ADDENDUM 1

DATE: May 25nd, 2018
PROJECT: MSB Penthouse AHU Replacement
ITB NO: 744-R1816 MSB Penthouse AHU Replacement
OWNER: The University of Texas Health Science Center at Houston
TO: Prospective Proposers

This Addendum forms part of and modifies Proposal Documents dated, April 27th, 2018, with amendments and additions noted below.

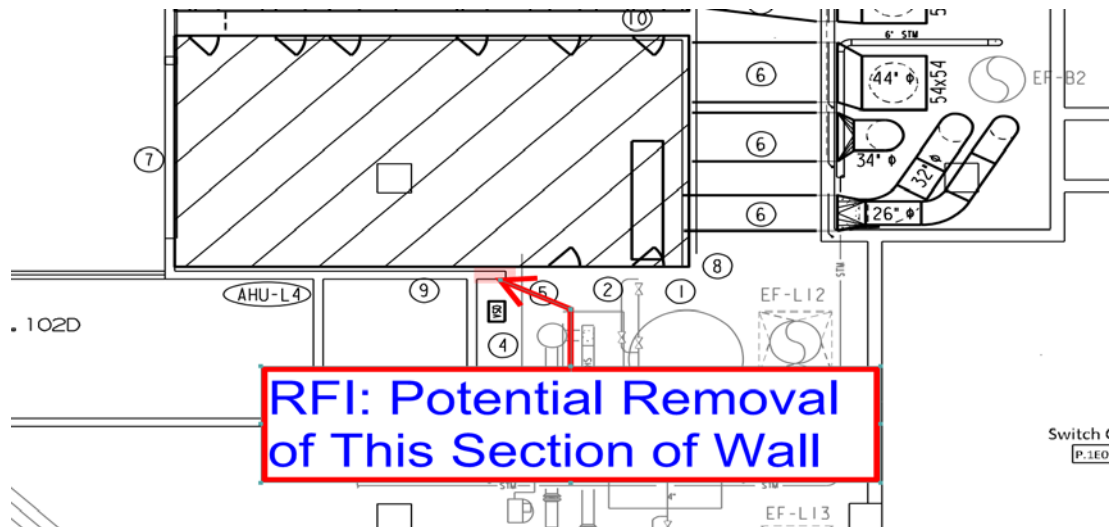
40.	M318		Would it be possible to eliminate the shaded section of wall in the drawing below to facilitate the location of the cooling coil condensate exit from the unit, and the condensate collection/reclamation tank?	Do not remove.
